Access Compliance Report

Public Rights-of-Way

(Curb Ramps)

Intersection ID: 11803	Main Street: MECKLENBURG_AV	Cross Street: DANIEL_ST	Location: NE
ADA ID: 2755D8695BFB	Ramp Type: BlendTrans1	Initial Pass/Fail: Fail	Overall Compliance: No
Severity Score: 1.25			
Codes/Mitigation Info/Possible Solution		Field Measurements/Component Compliance

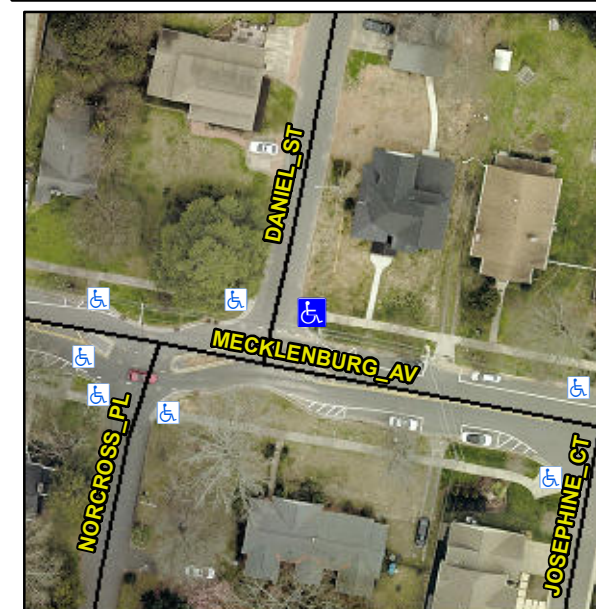
R304.5.3

Compliance	Description	Data	Compliance	Description	Data
N/A	Ramp Length (in)	150.0	Yes	BlendTrans Slope (%)	4.6
Yes	Ramp Width (in)	61.0	No	BlendTrans XSlope (%)	4.4
N/A	Flare Type LT	N/A	N/A	Flare Type RT	N/A
N/A	Flare Slope LT (%)	N/A	N/A	Flare Slope RT (%)	N/A
N/A	Flare Traversable LT?	N/A	N/A	Flare Traversable RT?	N/A
N/A	Landing Length (in)	N/A	N/A	DWS Provided?	N/A
N/A	Landing Width (in)	N/A	N/A	DWS Contrast?	N/A
N/A	Landing Slope (%)	N/A	N/A	DWS Length (in)	N/A
N/A	Landing X Slope (%)	N/A	N/A	DWS Full Width?	N/A
N/A	Landing Curb? (Y/N)	N/A	N/A	DWS Offset (in)	N/A
N/A	Shared Landing?	N/A			
N/A	Gutter Ponding?	N/A	N/A	Gutter Slope (%)	N/A
N/A	Gutter Lip Ht (in)	N/A	N/A	Gutter X Slope (%)	N/A
N/A	Painted X Walk1?	No	N/A	Painted X Walk2?	N/A
	X Walk 1 Direction	To W		X Walk 2 Direction	N/A
	X Walk 1 Width (in)	N/A		X Walk 2 Width (in)	N/A
	X Walk 1 Slope (%)	0.6		X Walk 2 Slope (%)	N/A
	X Walk 1 X Slope (%)	1.4		X Walk 2 X Slope (%)	N/A

Remove & Replace Curb Ramp With Two New Directional Ramps or Equivalent.
